10/597,360

Office Action Summary	Application No. 10/597,360	Applicant(s) TAKAHASHI, MASAMI	
	Examiner Leon W. Rhodes	Art Unit 2862

DETAILED ACTION

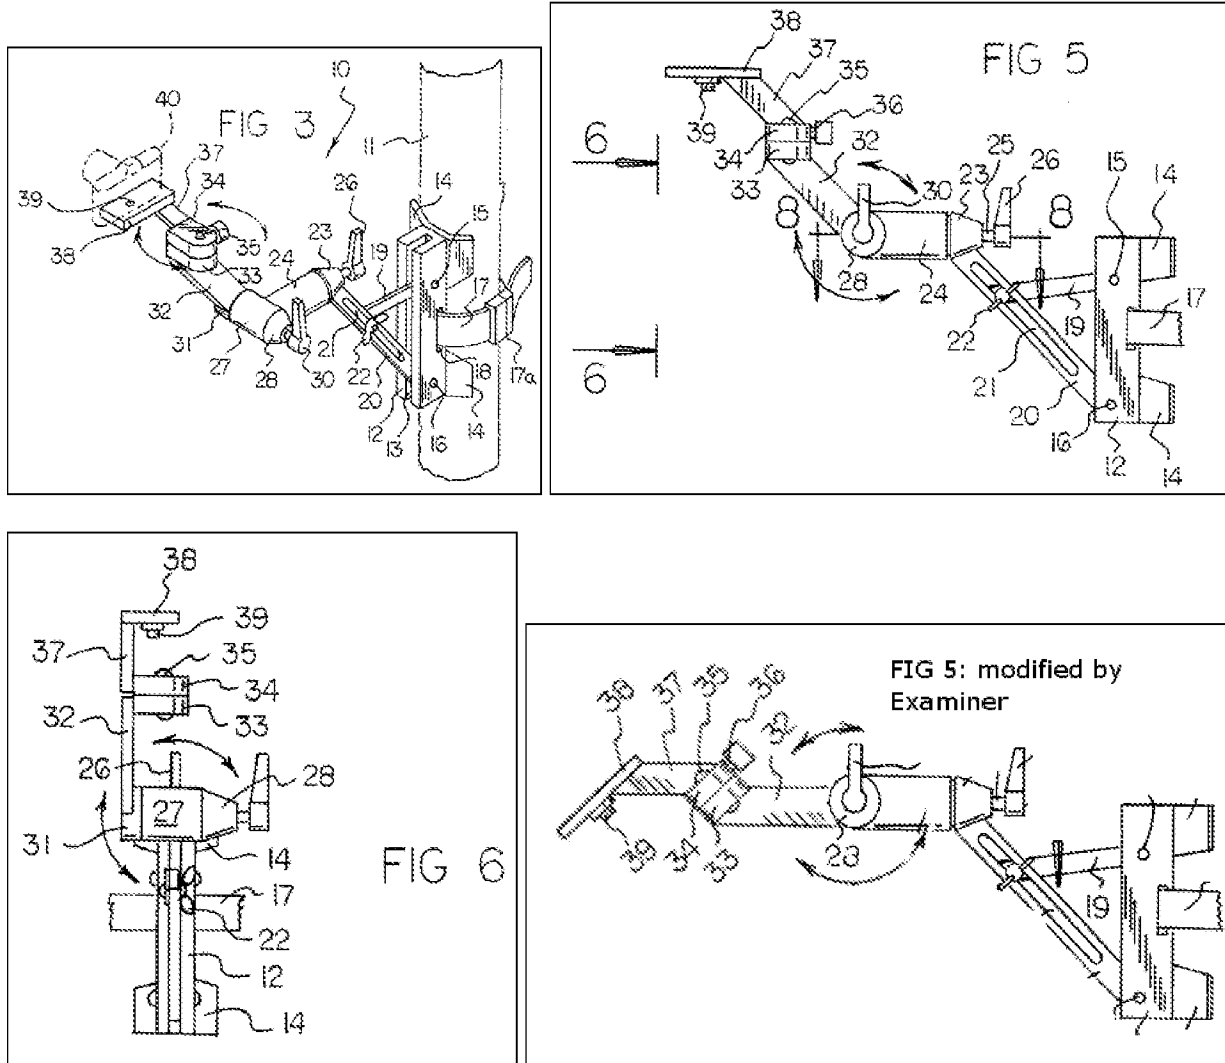
7. With regard to claim 1: Labree, in figures 3, 5, and 6 (provided below for convenient reference) , a camera installation device **10** comprising: a camera installation base **12** (bifurcated support boss) having an installation member **17** (flexible strap) for a camera installation surface (a pole **11** in the embodiment shown); and a camera support section **38** (support plate) and configured so as to support the camera **40**, wherein the camera installation member and the camera support section are coupled by a coupling section (a combination of **34**, **33**, **36**, and **35**, which together comprise a lockable rotating joint) having a fitting structure (axel **35** serves to hold the structure together) and wherein the coupling direction of the fitting structure between the camera installation base and the camera support section is inclined relative to a direction vertical to the camera installation surface (column 2, lines 57-65 discloses that the structure of Labree is designed to be articulated into an infinite number of arrangements, but of particular applicability is an arrangement similar to the arrangement shown in Figure 5, but where the second pivoting part is pivoted, resulting in the coupling direction of the camera support being inclined relative to the vertical direction of the installation base. This situation is illustrated by the Examiner in a **modified version of Fig 5**, shown below), and the coupling angle of the camera support section with respect to the camera installation base is variable (as indicated by the arrows around the rotating joint in Fig 3). The coupling angle between the camera support section with respect to the camera installation base is varied by changing an installation angle of the coupling section with the fitting structure between the camera support section and the camera

installation base (the angle of the top section of the coupling section **34**, best seen in Fig 6, is rotated with respect to the bottom section **33**, around axel **35**).

8. With regard to claim 2: Labree discloses that the camera installation device is configured to position the camera in a myriad of configurations, and as depicted above by the Examiner, one (and possibly many more) of those configurations results in the angle of inclination of the coupling support section being 45 degrees, and the camera support section can be inverted on the coupling reference surface by rotating the upper section **34** 180 degrees, resulting in the camera

support section pointing back toward the camera installation base. While this configuration is not expressly noted, it is an inherent configuration from the structure shown in the drawings.
